Project Name: Jax Car Wash

Description: Preliminary Site Plan approval and PB Approval

**RE: Jax Kar Wash- Preliminary Site Plan Review – 2<sup>nd</sup> Review**

**Preliminary Site Plan / Planned Business Review  
for  
White Lake Charter Township, Michigan**

PRE-DEVELOPMENT DRAINAGE MAP  
NOT TO SCALE

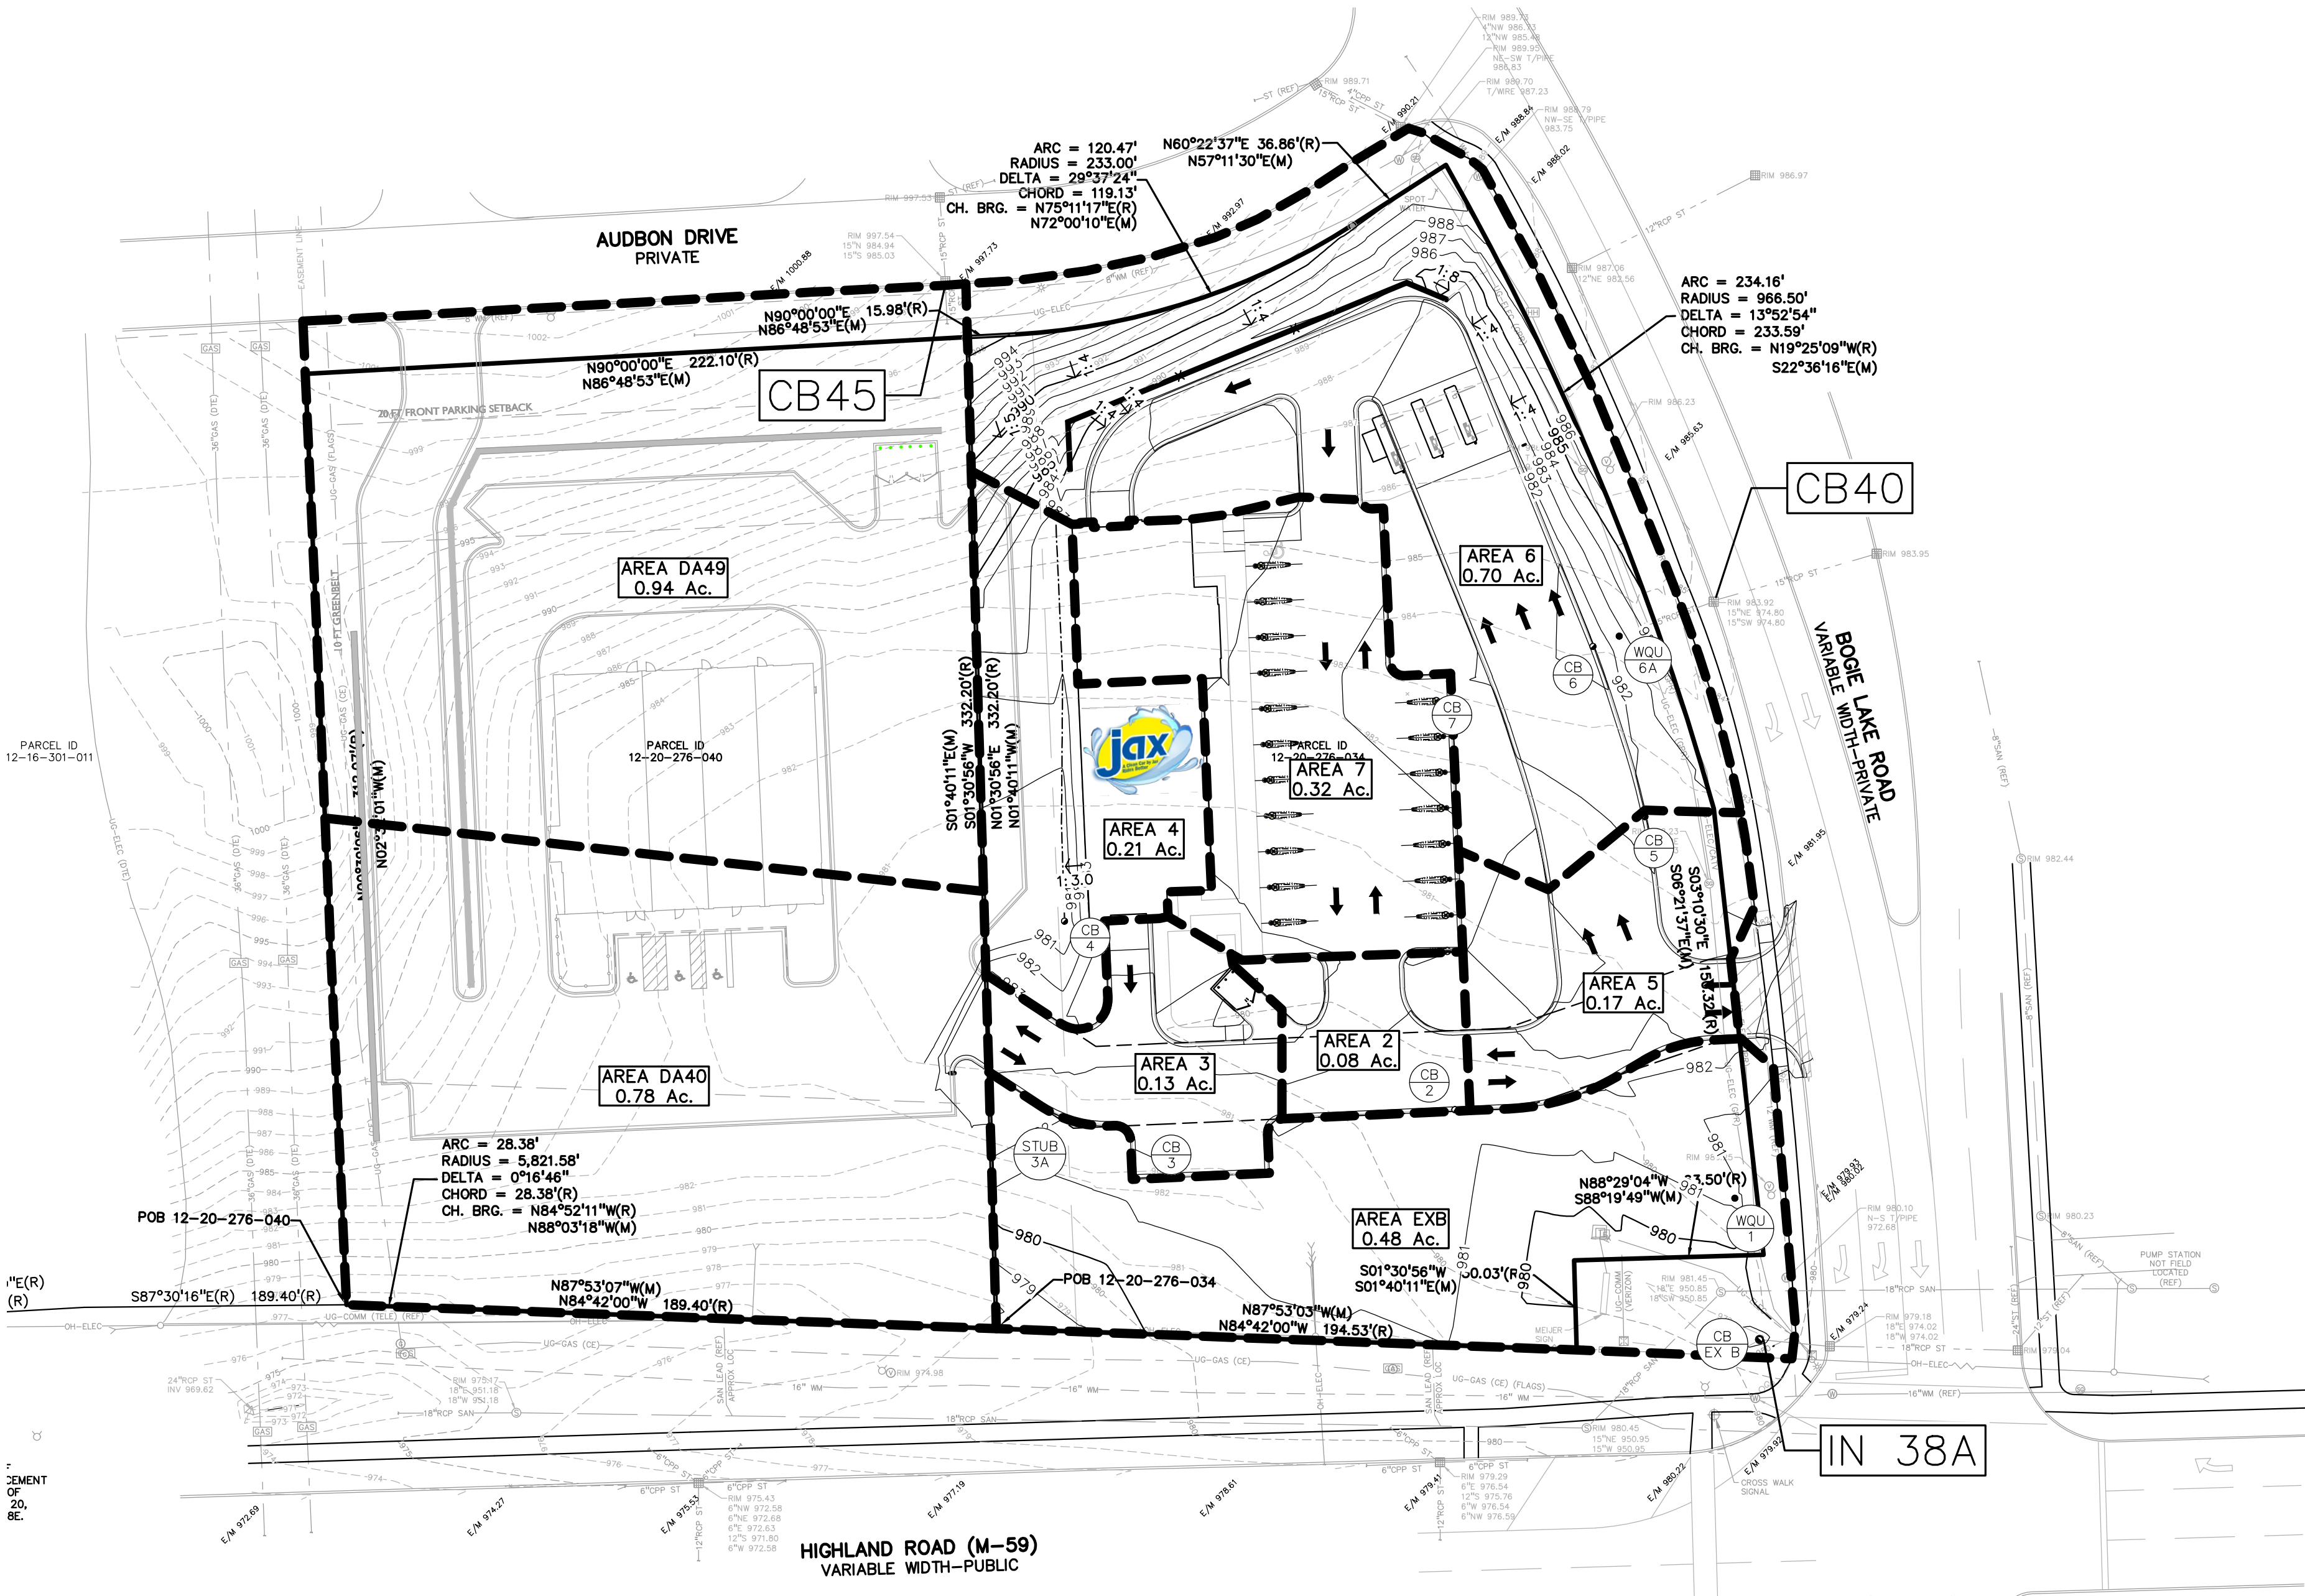
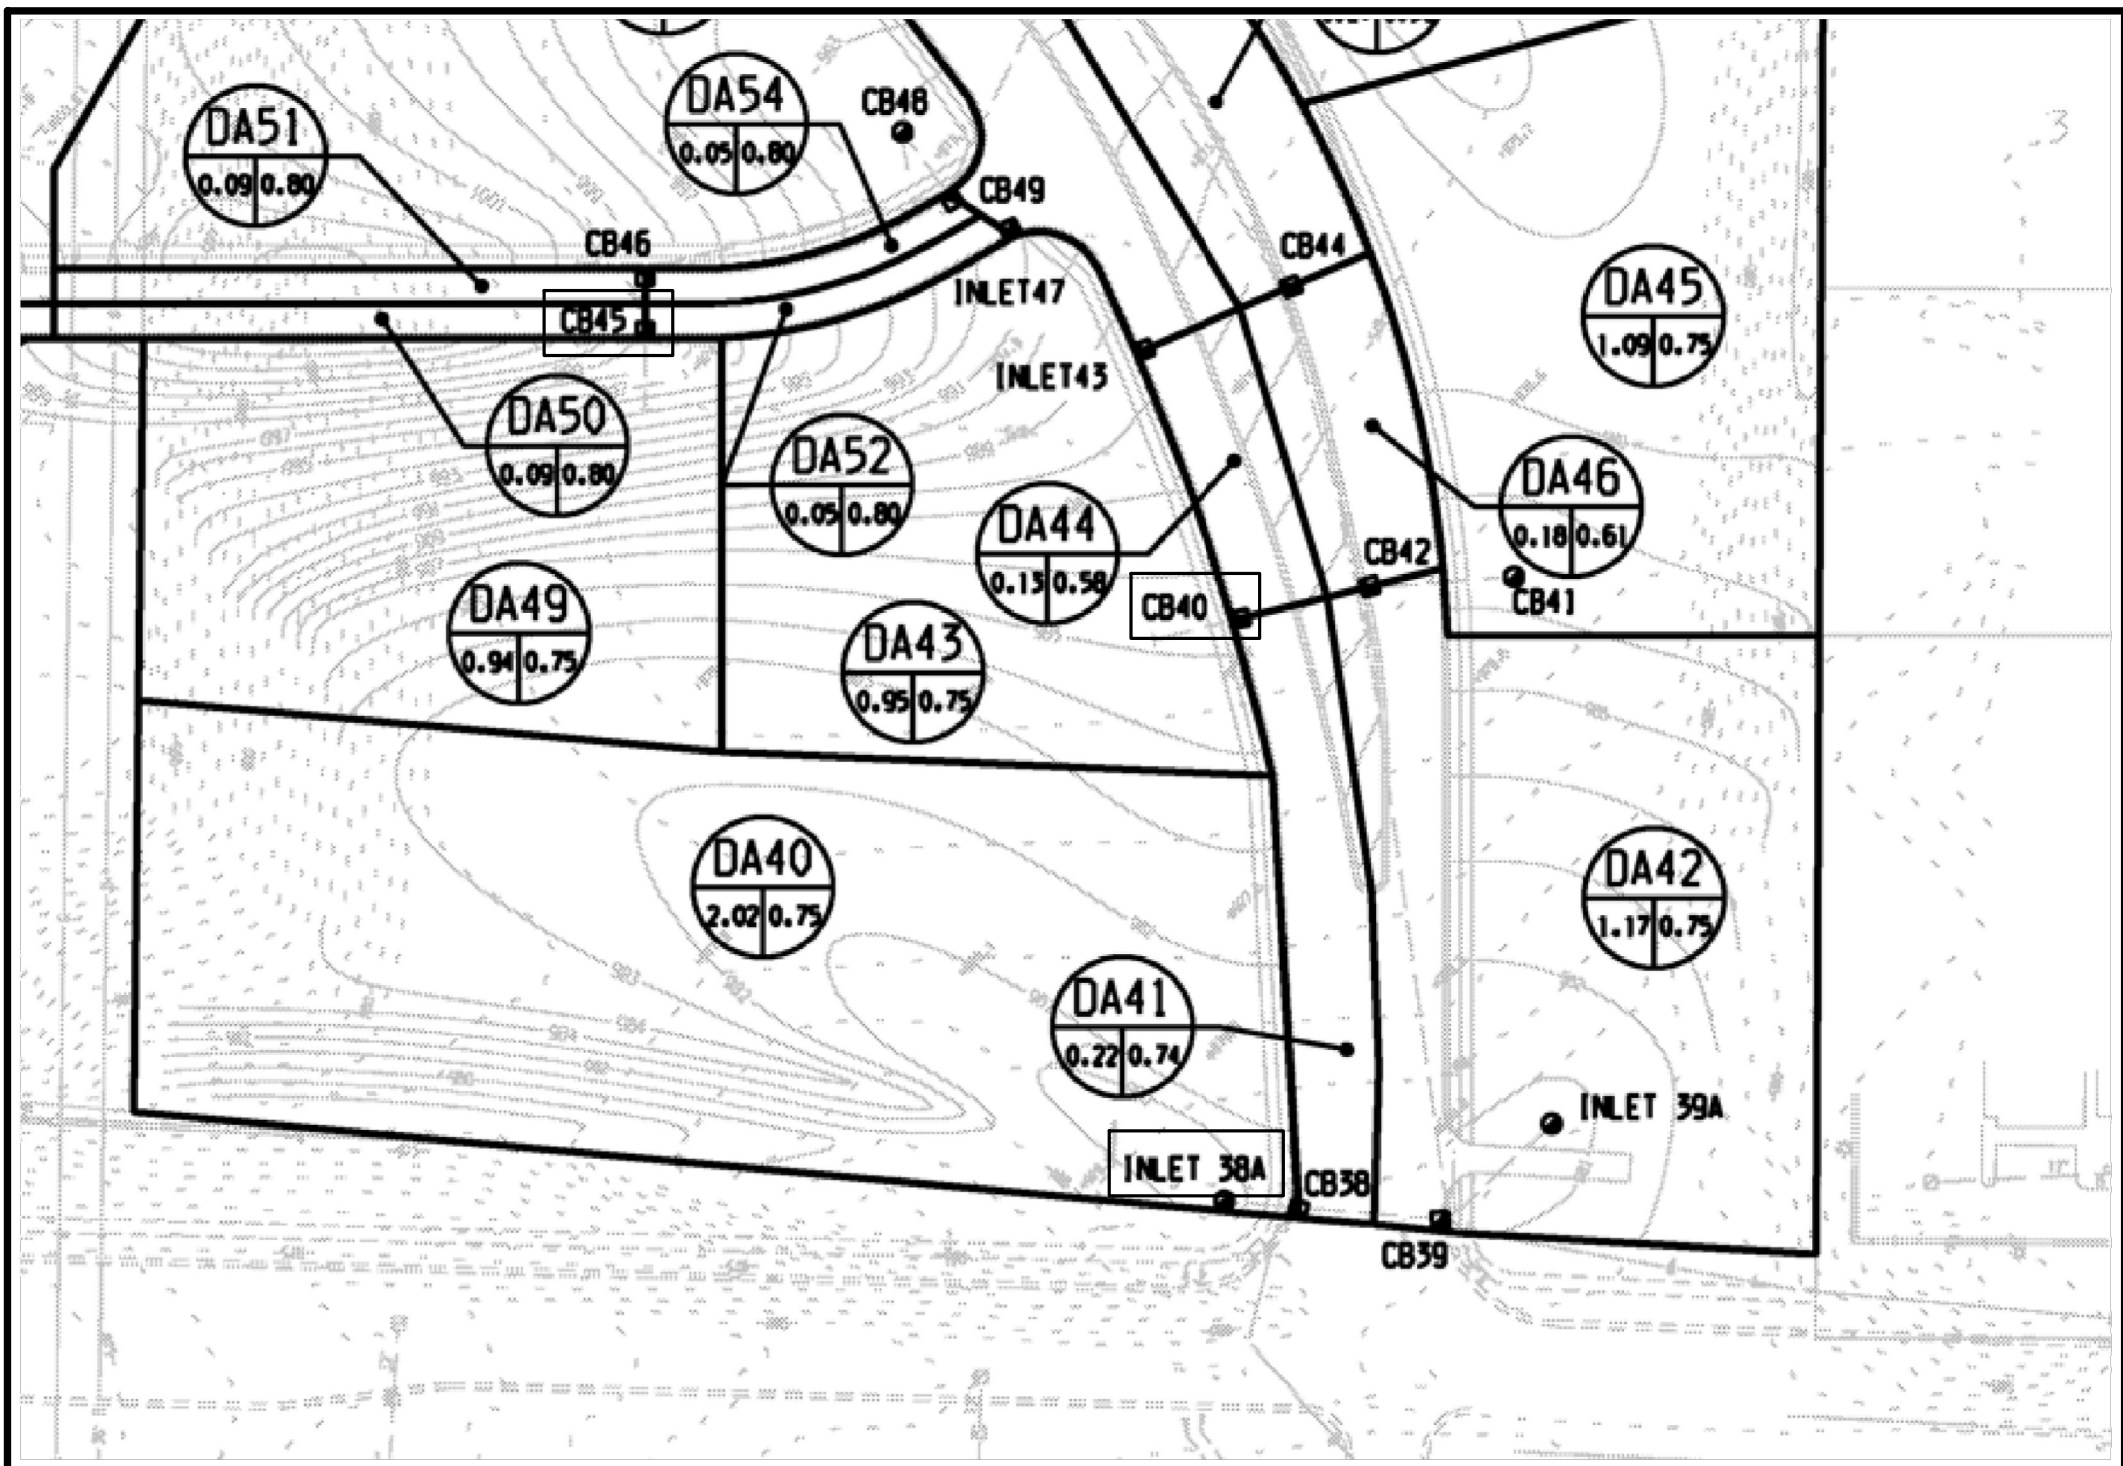
- p) *Show pre versus post development storm drainage that is being routed to the existing storm sewer structure near the corner of Highland Road and Bogie Lake Road. **Comment addressed. Calculations have been provided, and it has been demonstrated that there is sufficient capacity in the existing storm sewer to accommodate developed flows.***

7 TRANSFORMER SCREEN DETAIL  
NOT TO SCALE

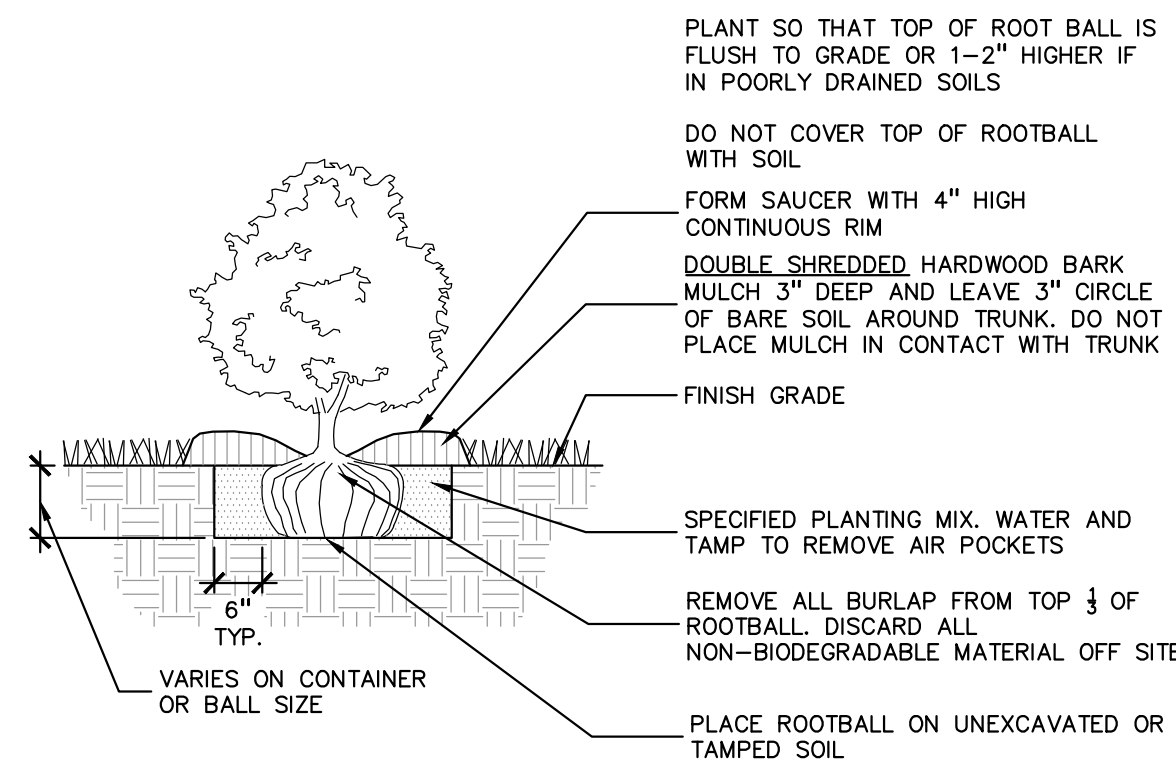
- 1) Planning Commission to consider waiver to allow for one deciduous or evergreen tree along the western greenbelt instead of the required eight trees.*
- 2) Bushes must be thirty (30) inches in height or spread.*
- 3) Height of screening for transformer should be added to the landscape plan.*
